The text reproduced below proposes amendments to ECE/TRANS/WP.29/2020/53 as a follow up of the last session of WP.29.

**PROPOSAL:**

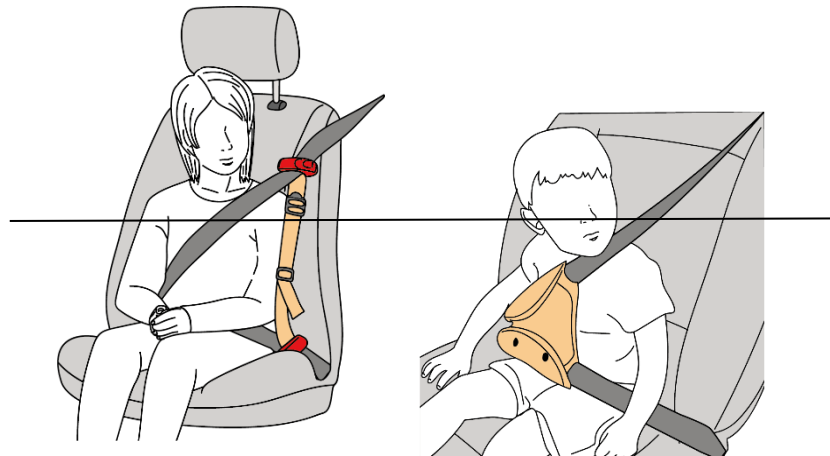
~~"1.2. This Regulation explicitly forbids child restraint systems in the form of belt guides and other sitting devices that are dangerous and can harm children in the event of a vehicle collision irrespective of any test results obtained in accordance with paragraph 8.~~

In particular, it concerns belt guides and sitting devices meant for children of a mass from 15 kg to 36 kg that connect to or attach onto the lap belt portion as well as the torso belt portion of a 3 point adult safety belt system with the aim to alter the adult safety belt routing by for example pulling down the torso belt portion or squeezing together the torso belt portion and lap belt portion. Examples of such non-compliant devices are shown below.

~~It also concerns sitting devices that are unusable by a child unless they are properly inflated or other compact sitting devices that attempt to guide the lap belt portion by keeping it down or forward, just above the seat cushion, rather than to significantly elevate the child in relation to the vehicle's normal seating position and the corresponding adult safety belt effective lower anchorages."~~

Upon further examination, the Commission identified that the text of the amendment in paragraph 1.2 was not in line with the General Guidelines for UN regulatory procedures and transitional provisions in UN Regulations. In reconsidering the drafting according to the above Guidelines, the Commission concluded that *de jure* the change proposed to paragraph 1.2 would not imply any changes to the current requirements of the Regulation, in particular that a 'guide strap' and similar devices cannot be separately approved as a child restraint system already under the current wording of Regulation No 44 as applicable since March 2012 (Interpretation by GRSP in December 2011 and endorsed by WP29 at its 156th session of WP.29 of March 2012).

For that reason, the Commission proposes to withdraw its initial draft amendment. The draft amendment by IC/ANEC regarding the phasing out of the Regulation is kept.

The Commission would like to underline that the withdrawal of its draft amendment does not change its understanding of paragraph 2.8.8. of Regulation 44 that approvals granted to guide straps that are not part of a child restraints systems are not valid.
